# **NATIONAL BOARD TASK GROUP HISTORICAL BOILERS**

## **AGENDA**

Meeting of July 13<sup>th</sup>, 2020  
Louisville, KY

FIGURE S2.10.2.3

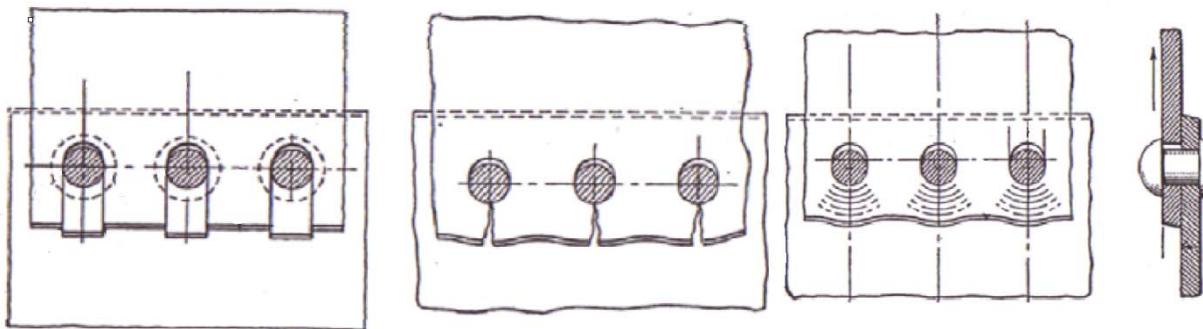
Figure S2.10.2.3 illustrates visual indicators of (c), (d), (e). Inspection shall visually inspect for cracked or stressed plate material along a riveted joint. Indications of failure shall be monitored or repaired, at the discretion of the jurisdiction.

- a.) Rivets may shear off.
- b.) The plate may tear along the centerline of the row of rivets.
- c.) The plate may shear in front of the rivets.
- d.) The plate may tear from the outer edge of the rivet hole to the caulking edge.
- e.) The plate may crush in front of the rivets.

FIG. 19

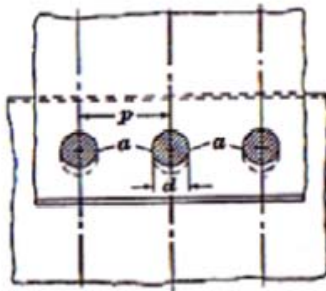
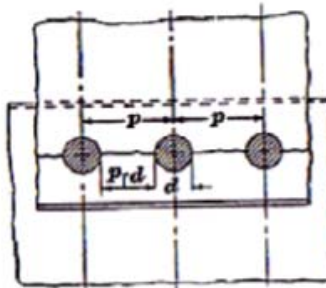
1. The rivets may shear off, as shown in Fig. 19.

2. The plate may tear along the center line of the row of rivets, as shown in Fig. 20.

### **Lap Outside Rivet Holes**

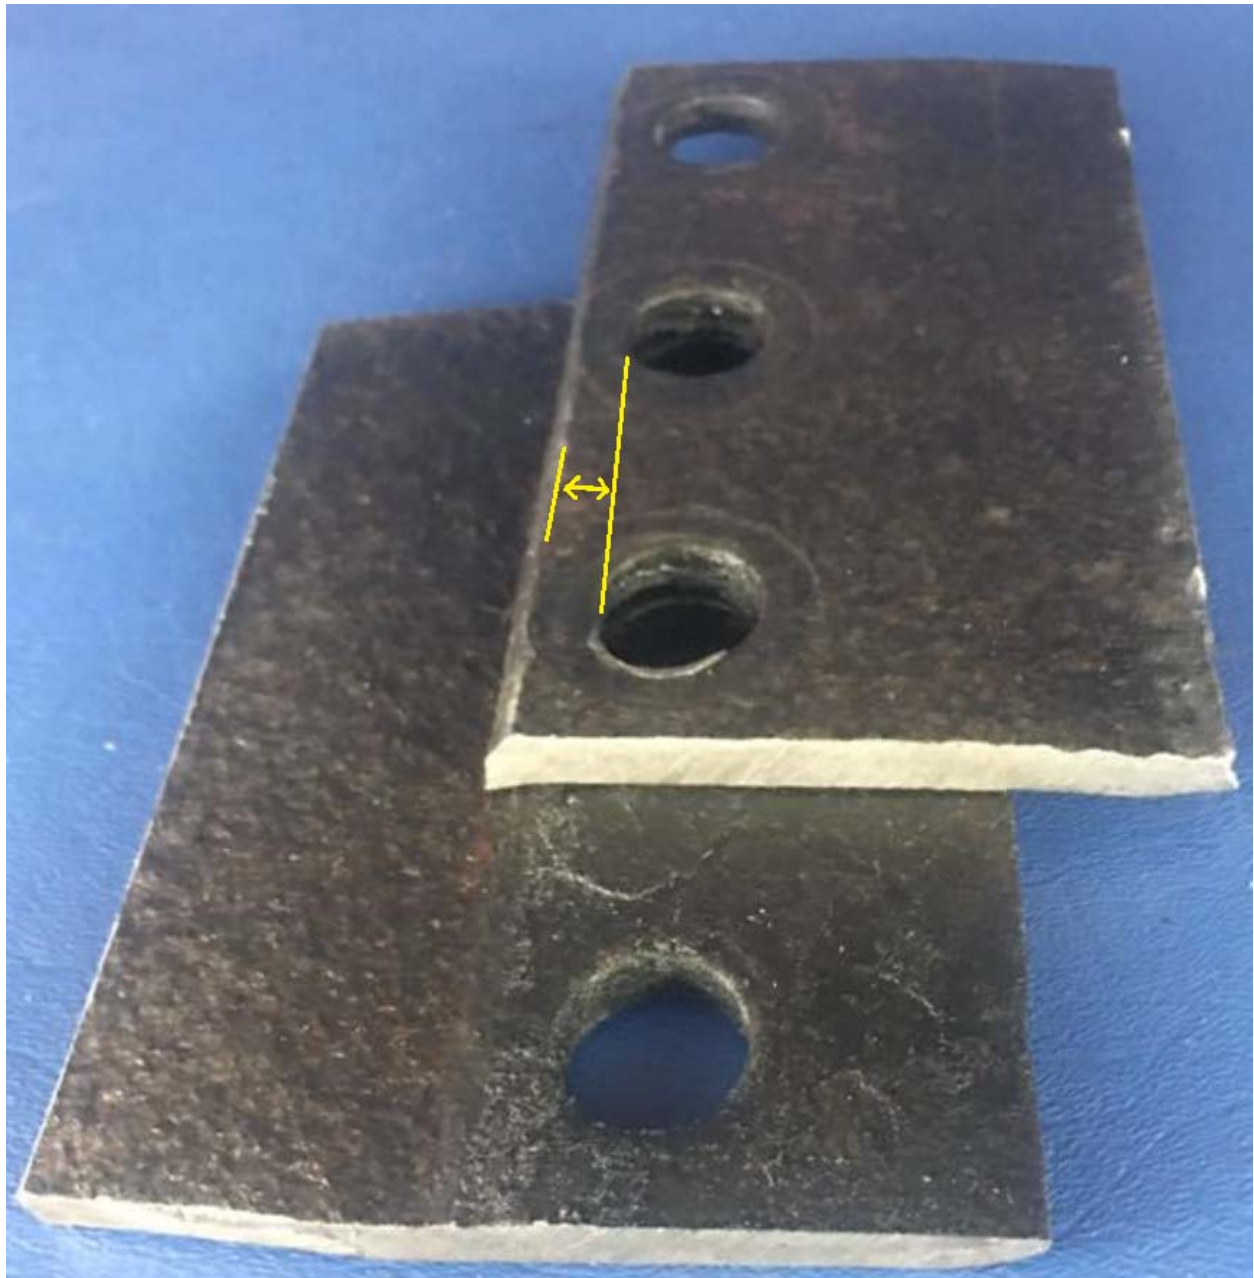
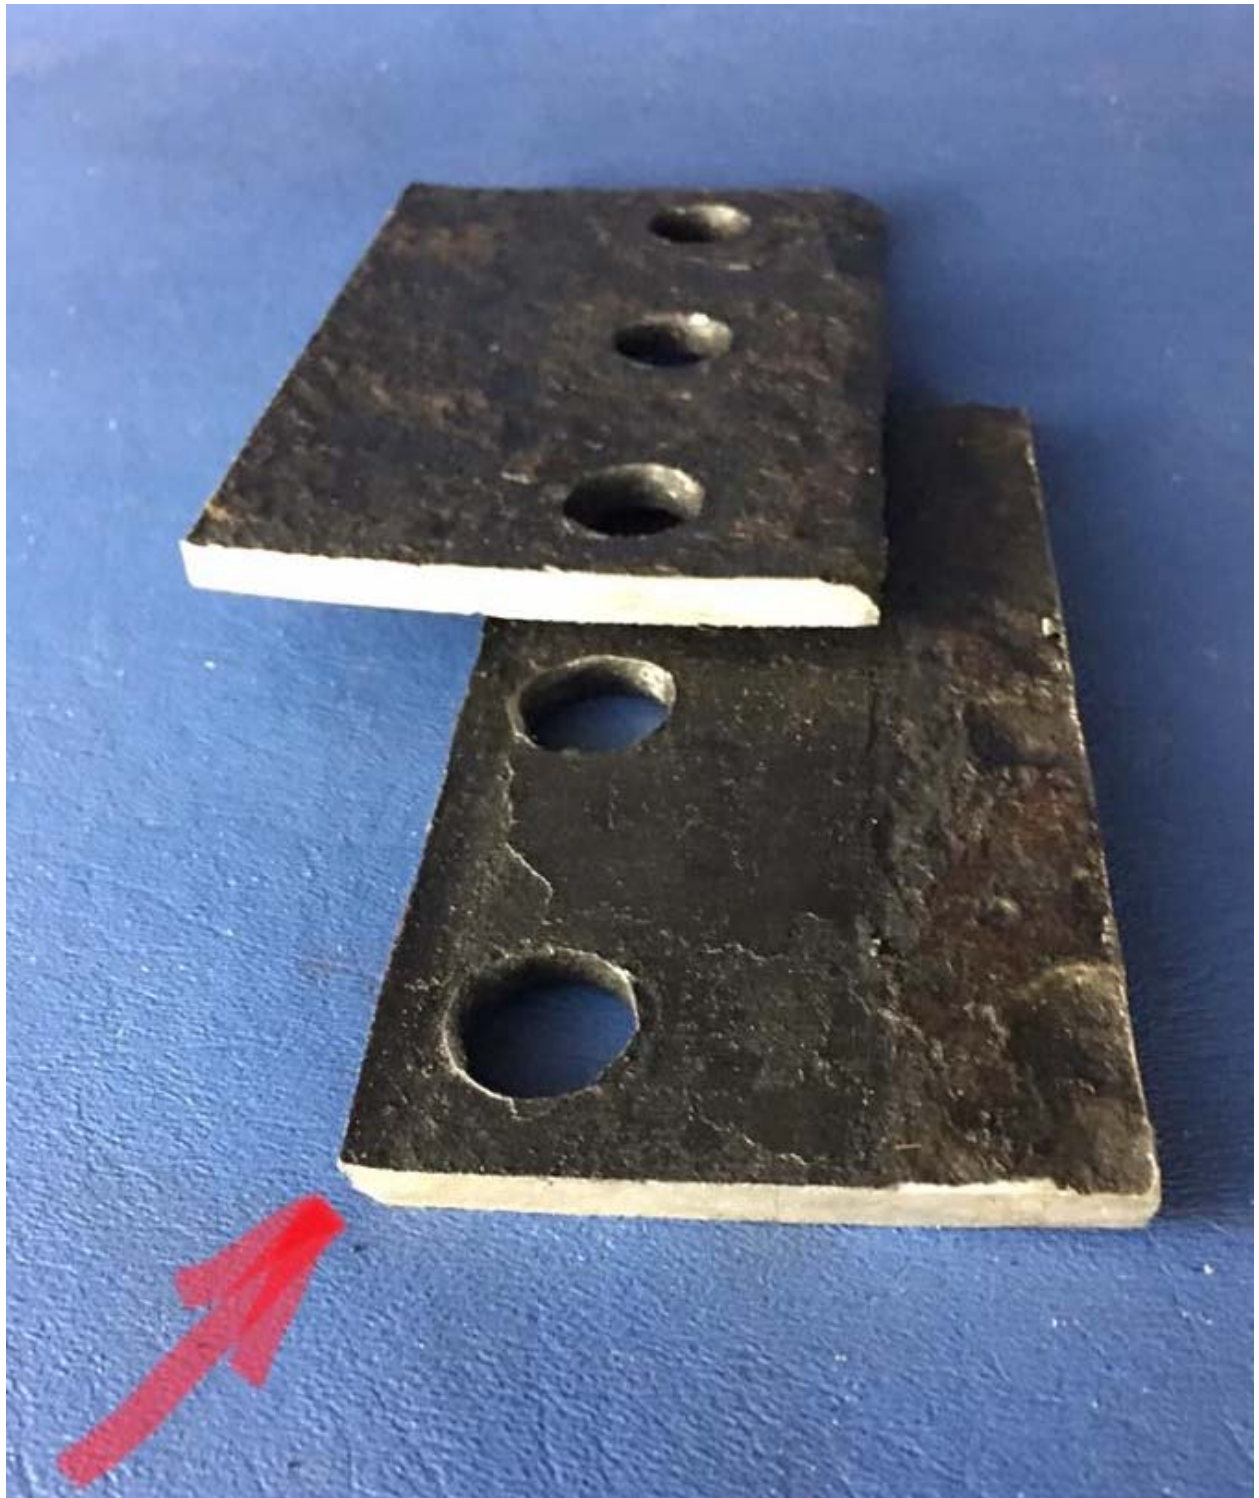
199. The lap of plate outside rivet holes measured from the outer edge of the rivet holes to edge of plate must be at least equal to diameter of rivet hole, and must not be more than 1/8 inch in excess of the diameter of the rivet hole.
